SUBJECT: PEACH BOTTOM ATOMIC POWER STATION, UNITS 2 AND 3 - STAFF ASSESSMENT OF INFORMATION PROVIDED PURSUANT TO TITLE 10 OF THE *CODE OF FEDERAL REGULATIONS* PART 50, SECTION 50.54(f), SEISMIC HAZARD REEVALUATIONS RELATING TO RECOMMENDATION 2.1 OF THE NEAR-TERM TASK FORCE REVIEW OF INSIGHTS FROM THE FUKUSHIMA DAI-ICHI ACCIDENT (TAC NOS. MF3866 AND MF3867)

STAFF ASSESSMENT BY THE OFFICE OF NUCLEAR REACTOR REGULATION

RELATED TO SEISMIC HAZARD AND SCREENING REPORT

PEACH BOTTOM ATOMIC POWER STATION, UNITS 2 AND 3

Figure 3.3-1 Plot of Staff's and Licensee's Base Case Shear-Wave Velocity Profiles

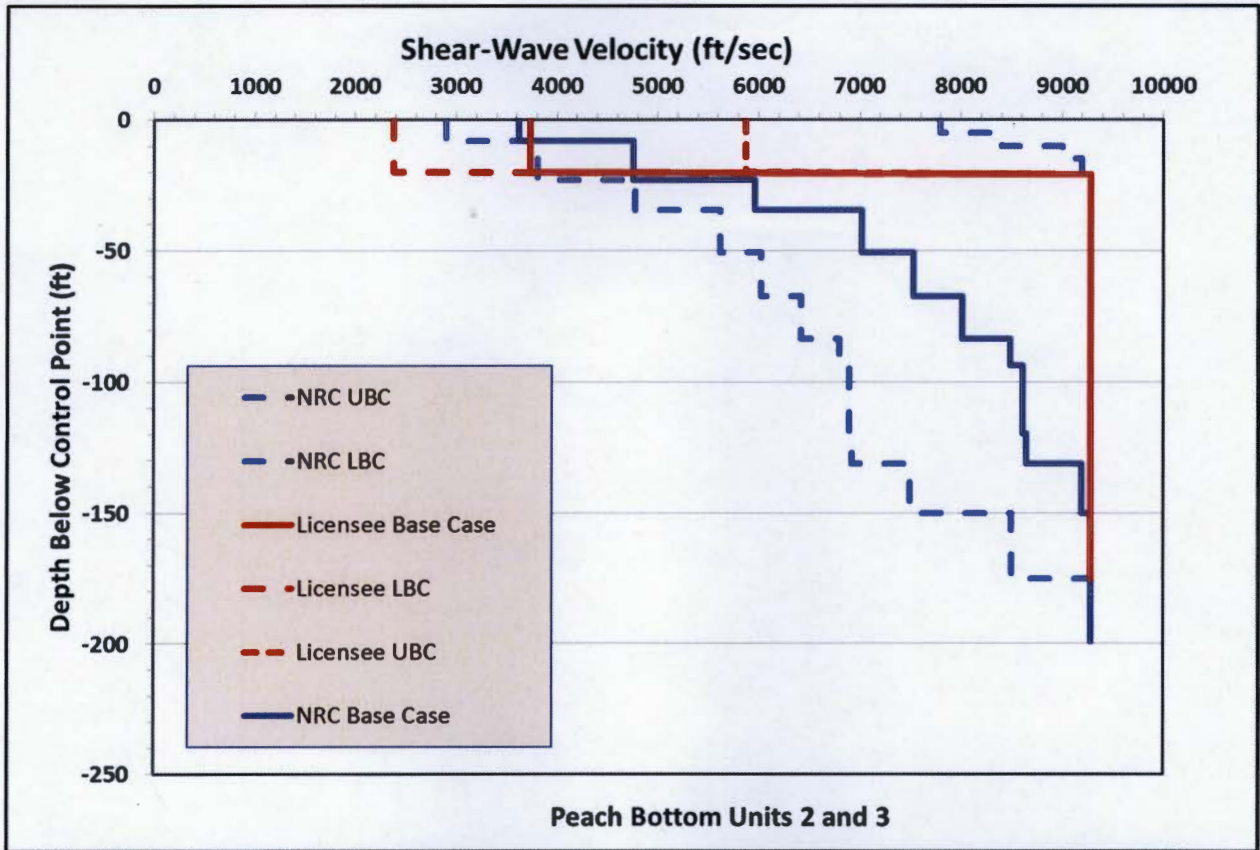
To capture the uncertainty in the shear wave velocities at the Peach Bottom site for the approximately 20 ft (6.1 m) of weathered rock, the licensee developed three base case profiles. For the best estimate or base case shear-wave velocity profile, the licensee used a shear-wave velocity of 3,742 ft/s (1,141 m/s). To develop the upper and lower base case profiles, the licensee used a standard deviation of 0.35 (corresponding to a scale factor of 1.57 for the 10th and 90th percentile values) to estimate the lower and upper base case shear-wave velocity profiles. These estimated velocities ranged from 2,383 to 5,874 ft/sec (728 to 1,790 m/s) in the upper 20 ft (6.1 m). Figure 3.3-1 in this assessment shows the licensee's shear-wave velocity profile for each of the three base cases.

As discussed above, no in-situ seismic wave velocities are available in the Peters Creek schist at the Peach Bottom site. Laboratory measurements of compressional-wave velocities and unit weights were obtained from core samples (using shock-scope tests) from several boreholes at selected depths (documented in UFSAR Table 2.5.2). The staff independently developed shear-wave velocity profiles based on an analysis of the available data and augmented by additional reference material. The staff concluded that the average of the measured near-surface compressional-wave velocities in the moderately weathered schist is approximately 7000 ft/sec (2134 m/s). Based on Poisson's ratio values appropriate for schist at near-surface conditions (Bourbie, et al. (1987), Sheriff and Geldart (1995)), the staff concluded a shear-wave velocity of 3620 ft/sec is appropriate for the base case profile at the control point elevation. This value is similar to that cited in the General Atomics study and the value used by the licensee of 3742 ft/s (1141 m/s). To develop upper and lower base case profiles, the staff used the observed range of compressional wave velocities and an appropriate range of Poisson's ratio for these materials (0.28 to 0.34). The lower and upper profiles used in the NRC staff assessment have shear wave velocities of 2901 ft/sec (lower base case) and 8185 ft/sec (upper base case), respectively. Rather than using a single shear wave velocity value and a thickness of 20 ft (6.1 m) for the depth to reference or base rock, the staff's base case profiles used the velocity templates described in Appendix B of the SPID to more realistically model the subsurface of the Peach Bottom site. Figure 3.3-1, in this assessment, compares the staff's base case profiles to those developed by the licensee.

Figure 3.3-2 Comparison of the Licensee's and NRC Staff's Median Amplification Functions and Uncertainties (Sigma Ln(AF)).

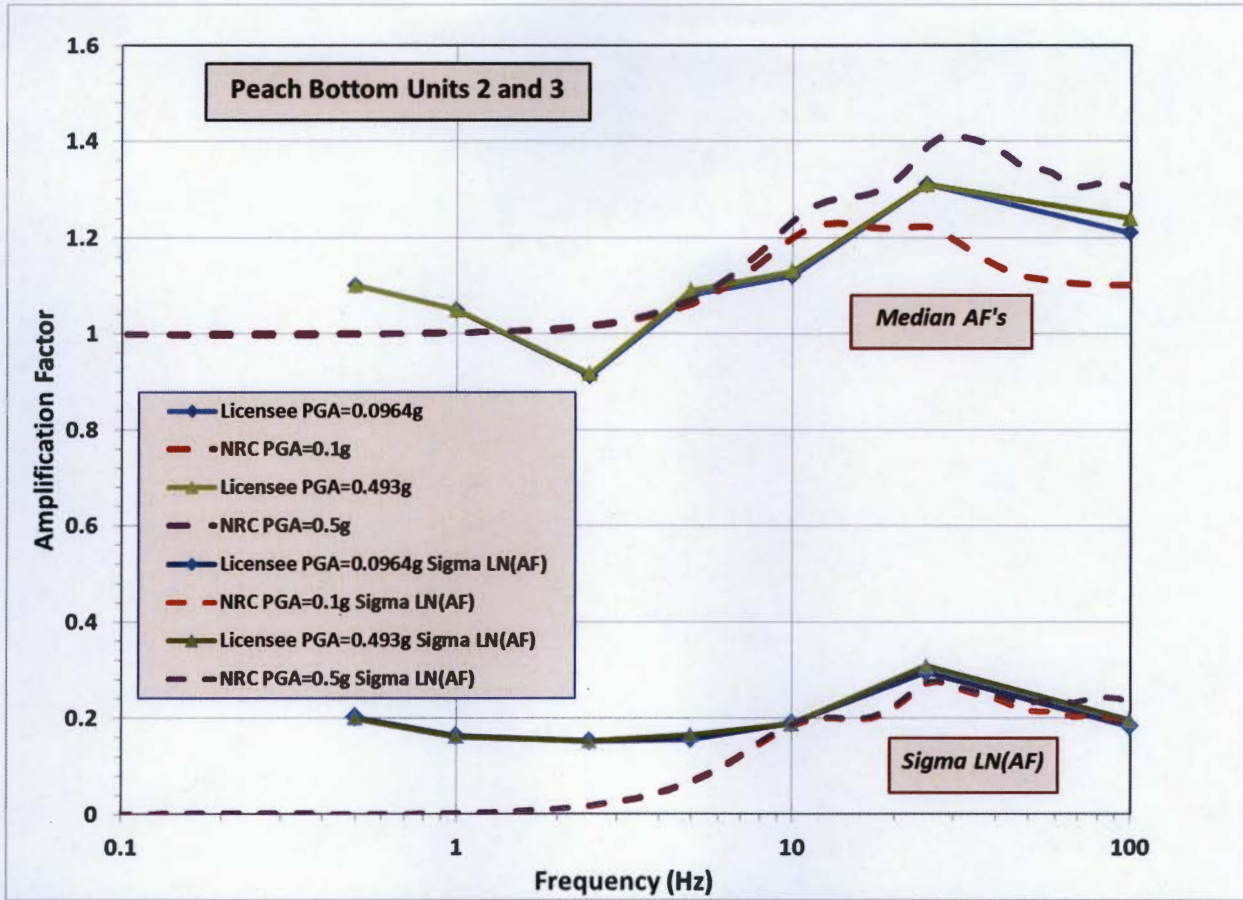
Figure 3.3-2 compares the staff's and licensee's median site amplification functions and uncertainties for two of the eleven input loading levels. The results are very similar with a modest site amplification of about 1.2 to 1.4 at about 30 Hz. As shown in Figure 3.3-4, the minor differences in the site response analyses between the licensee and staff have a minimal impact on the resulting control point seismic hazard curves. Appendix B of the SPID provides guidance for performing site response analyses, including capturing the uncertainty for sites with less

Figure 3.4-1 Comparison of the Staff's GMRS with Licensee's GMRS and the Peach Bottom Units 2 and 3 SSE.

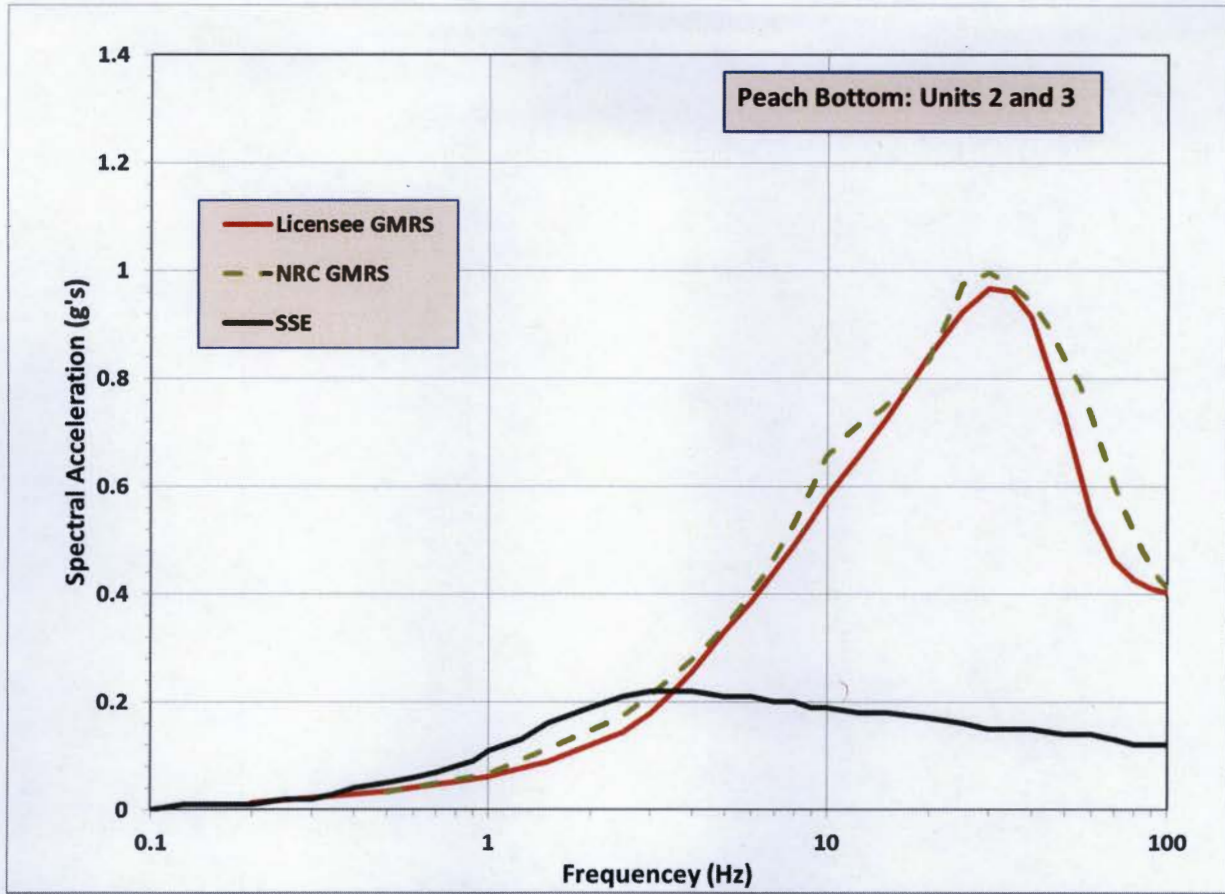
The staff independently obtained the 10^{-4} and 10^{-5} UHRS using the results of its confirmatory PSHA and site response calculations described in Sections 3.2 and 3.3 of this staff assessment, respectively. As shown in Figure 3.4-1 of this assessment, the licensee's GMRS shape is very similar to that calculated by the staff. As described above in Section 3.3, the staff concludes that these minor differences over the higher frequency range are primarily due to the differences in assumptions made in the site response analyses performed by the licensee and staff. The staff concludes that these differences are acceptable because the licensee followed the guidance provided in the SPID with respect to both the PSHA and site response analysis for the Peach Bottom site.
